The Challenge Machinery Company

PRODUCT SAFETY BULLETIN

Product: 370 X cutter

Description: Notch in Clevis may not be deep enough

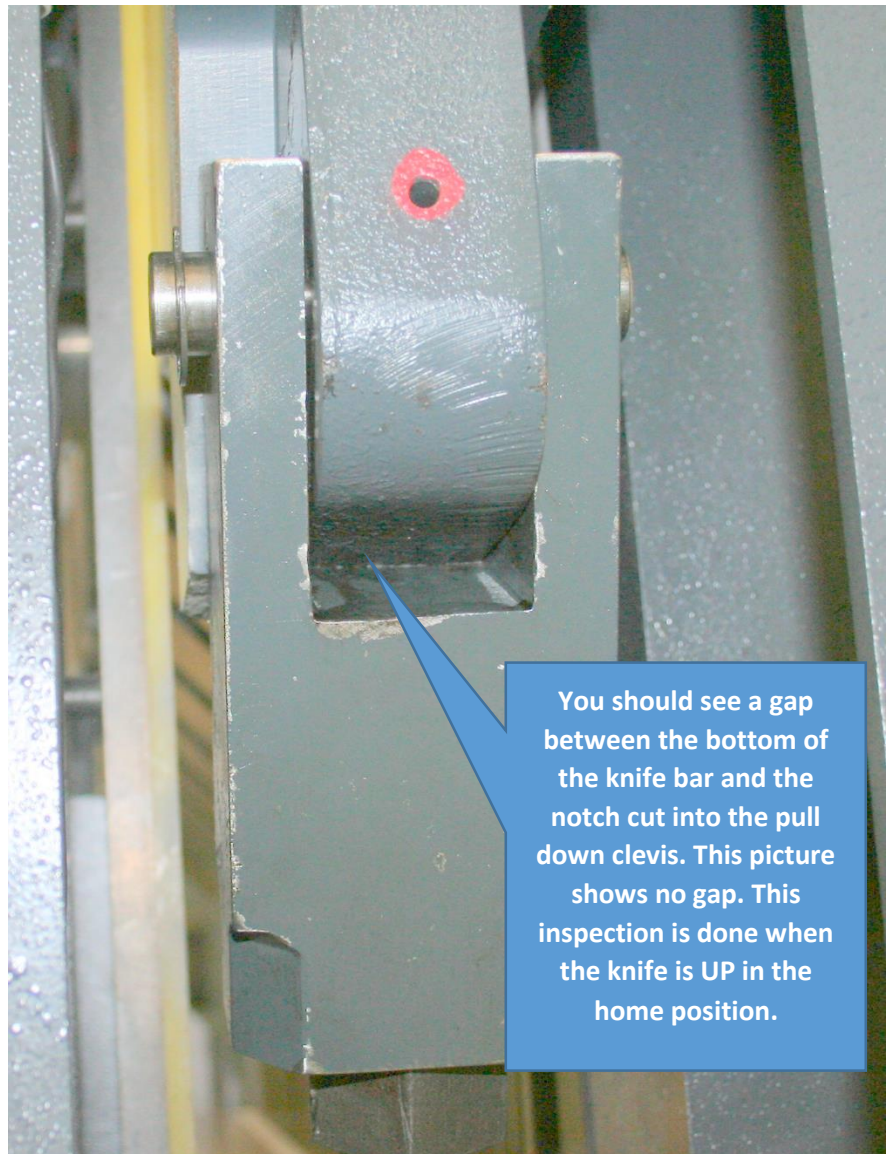
This inspection should be done when the knife is in the up position and the power to the machine turned OFF. You should see a gap between the notch cut in the knife pull down clevis and the knife bar casting. See photo, in this photo there is no gap. If your machine does not have a gap at this location contact Challenge Machinery for a replacement clevis.

You should see a gap between the bottom of the knife bar and the notch cut into the pull down clevis. This picture shows no gap. This inspection is done when the knife is UP in the home position.
